ASB-1037

Service Bulletin

Subject: TH-78 IMD Improvements

Date: January 5, 1994

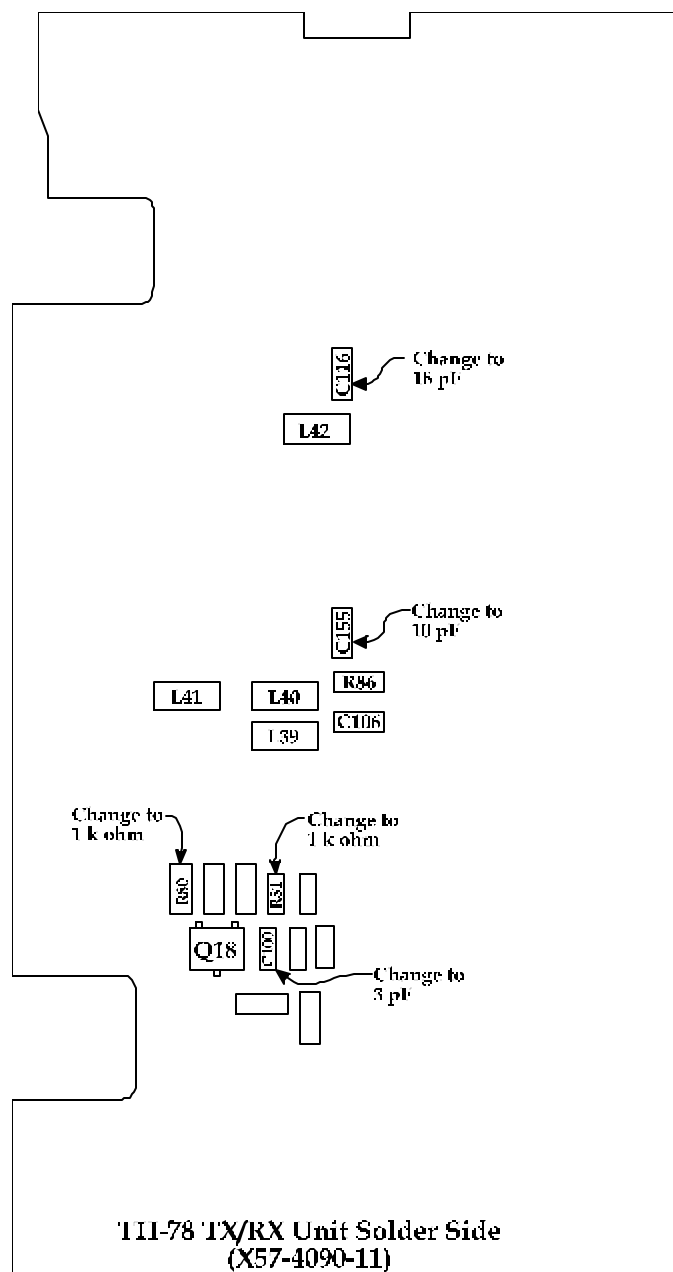
1. Change R80 from 390 ohm to 1 k ohm.
2. Change R81 from 3.9 k ohm to 3.3 k ohm.
3. Change C100 from 1 pF to 3pF.
4. Change C118 from 33 pF to 18 pF.
5. Change C155 from 1000pF to 10 pF.

(See diagram on page 2 for parts locations.)
